OLD BEGA HOSPITAL
ARTS & CULTURAL CENTRE

DESIGN DEVELOPMENT
29.03.2018

REVIEW OF FEEDBACK ITEMS

PLAN OF WOMANS WARD- DOORS OPEN

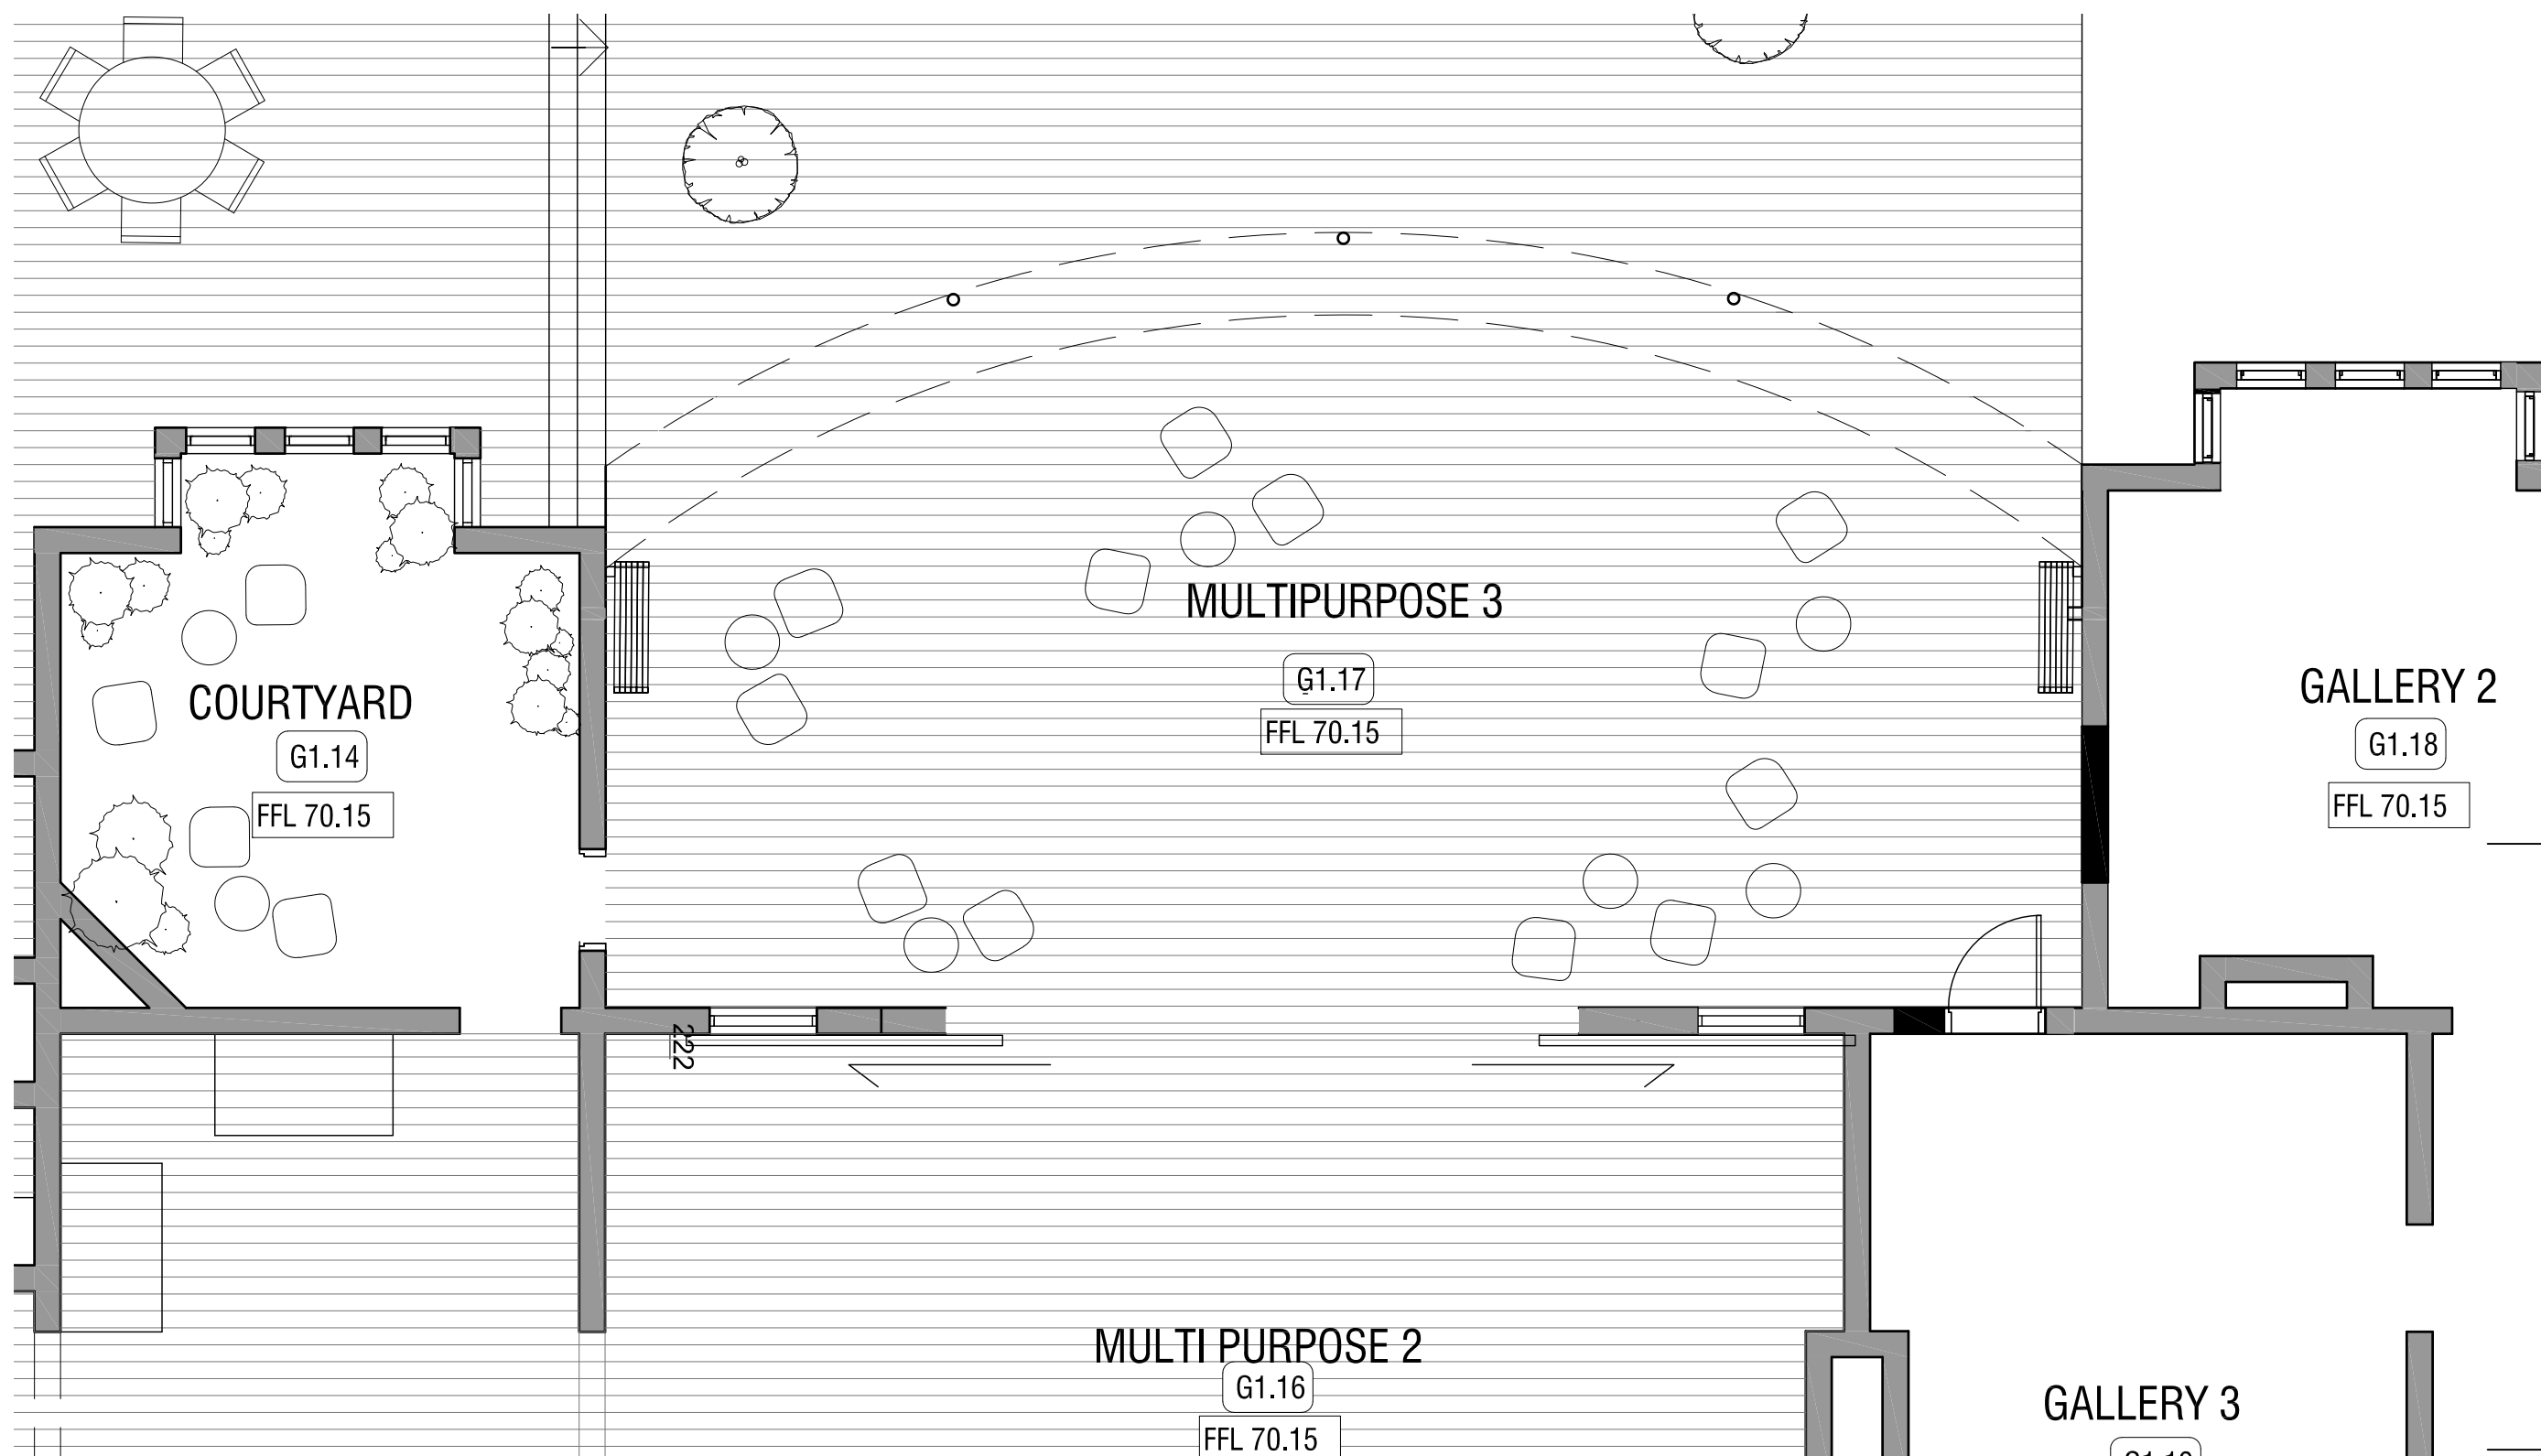
1. THE WOMEN'S WARD VERANDAH FACIA IS HIGHER (BIGGER VERTICAL DIMENSION) THAN THE MEN'S WARD FACIA. SHOULD THE MEN'S WARD ONE BE MADE TO MATCH?
2. HOW DOES THE WOMEN'S WARD VERANDAH STORMWATER COLLECTION AND DISPOSAL WORK?
3. THE ROOF OF THE WOMEN'S AND MEN'S WARD VERANDAHS SEEM TO BE ATTACHED TO THE BRICKWORK SOME DISTANCE BELOW THE WINDOWS ABOVE. WHILE THE CENTRAL VERANDAH IS ATTACHED IMMEDIATELY BELOW THE WINDOWS. DOES THAT MEAN THE WARD VERANDAH ROOFS ARE FLAT? OR DO THEY DRAIN BACK TO THE MAIN BUILDING?
4. THE WESTERN END OF THE OPERABLE OPENING OF THE WOMEN'S WARD VERANDAH DOES NOT APPEAR TO BE ATTACHED TO THE BUILDING.

HEIGHT OF ROOF WHERE IT ATTACHES TO THE MAIN BUILDING
